**VAN DEURZEN AND ASSOCIATES, P.A.**  
CONSULTING STRUCTURAL ENGINEERS  
11011 KING STREET, SUITE 130  
COMMERCE TERRACE BUILDING D  
OVERLAND PARK, KANSAS 66210  
(913) 451 - 6305 FAX (913) 451 - 1021

**Re: 1406-08 SW Winthrop Ter. - Framing Evaluation Report**  
**Lee's Summit, MO**  
**Bldg. Permit No.: PRRES20245916**

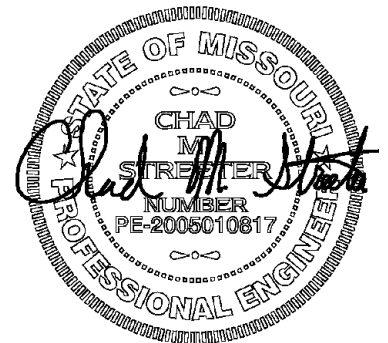
This letter is in regard to our evaluation of the ridge splice for the above mentioned duplex. During our initial inspection, we had noted that the ridge was not continuous and had been spliced. We had recommended that a second 2x8 be sistered to the ridge and extend beyond the splice on each end a minimum of two feet.

Once the recommended repair had been completed, we had noted that the sistered 2x8 had been installed in accordance with our initial recommendation. Based on our evaluation, the ridge is adequately tied together and no further corrective action is required.
